DATE: 10-01-96
JOB NO. 62011.212
DCN NO. UNIT 2A - 2
AGENCY NO.

REVISION DESCRIPTION: REVISE SOUTHERLY DROP INLET ON ALTA DRIVE STA. 529+09.23 FROM 6' MODIFIED TYPE "C" TO 12' TYPE "A".

DATE: 10-01-96
JOB NO. 62011.212
DCN NO. UNIT 2A - 1
AGENCY NO.

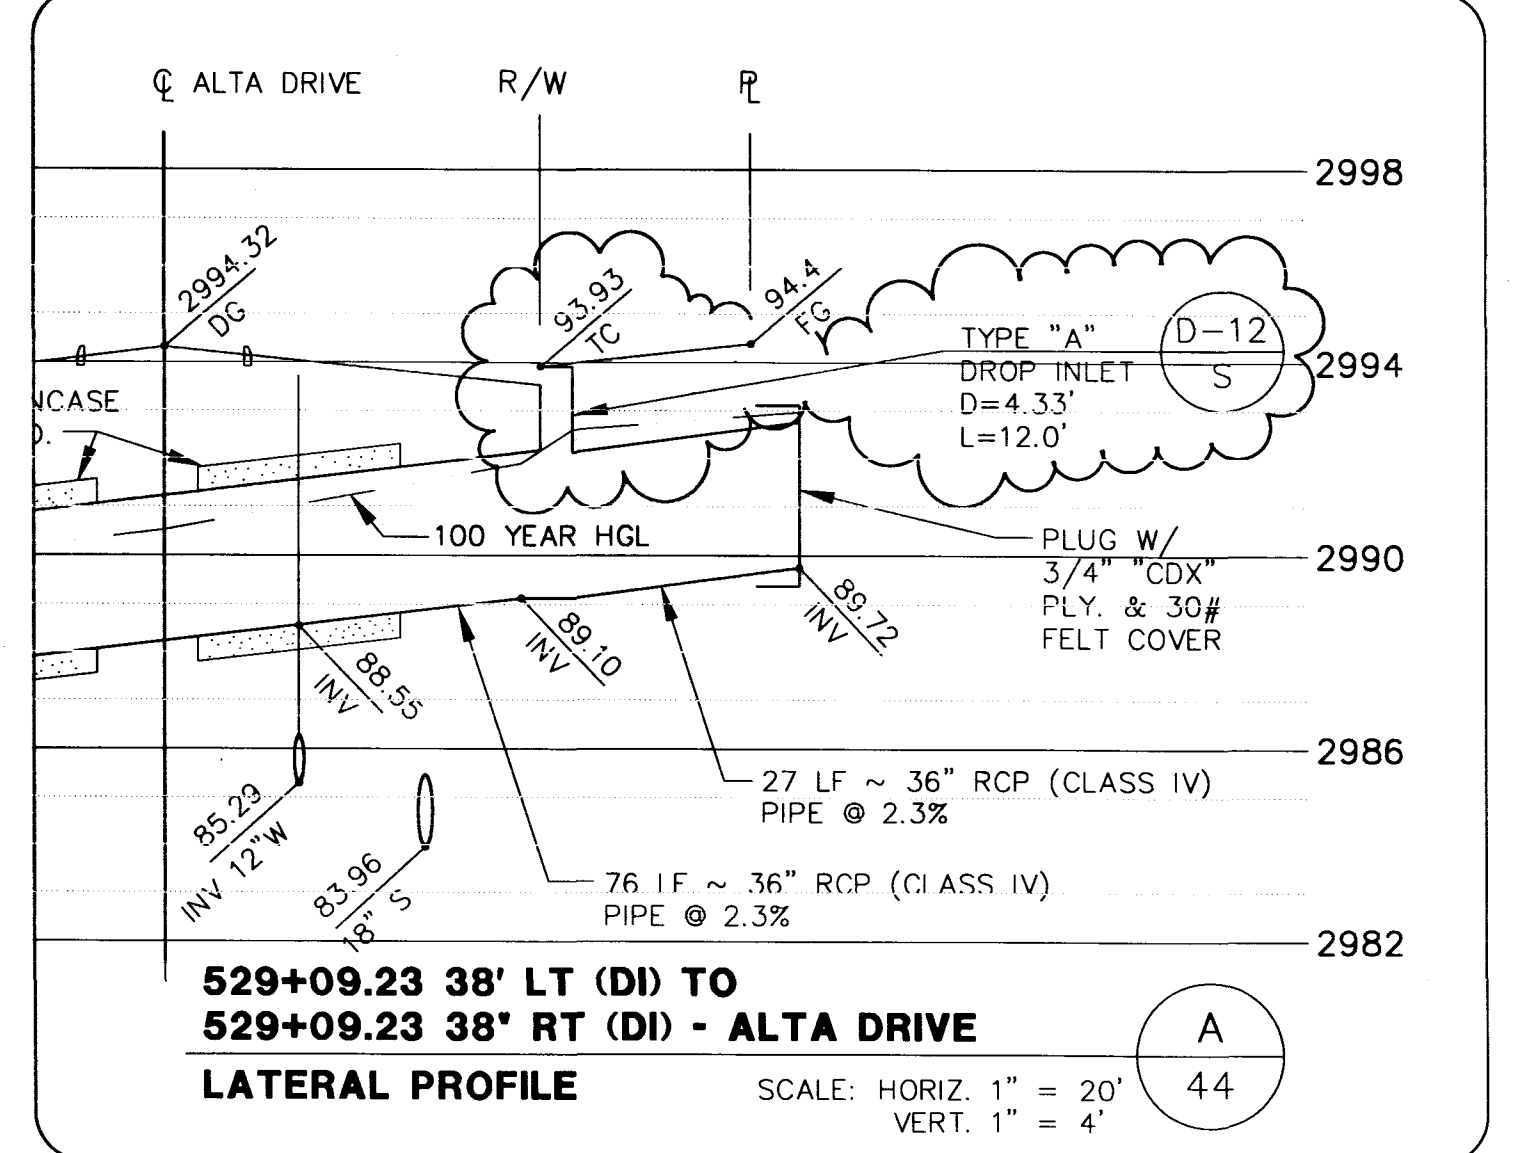
REVISION DESCRIPTION: REVISE SOUTHERLY DROP INLET ON ALTA DRIVE STA. 529+09.23
FROM 6' MODIFIED TYPE "C" TO 12' TYPE "A".
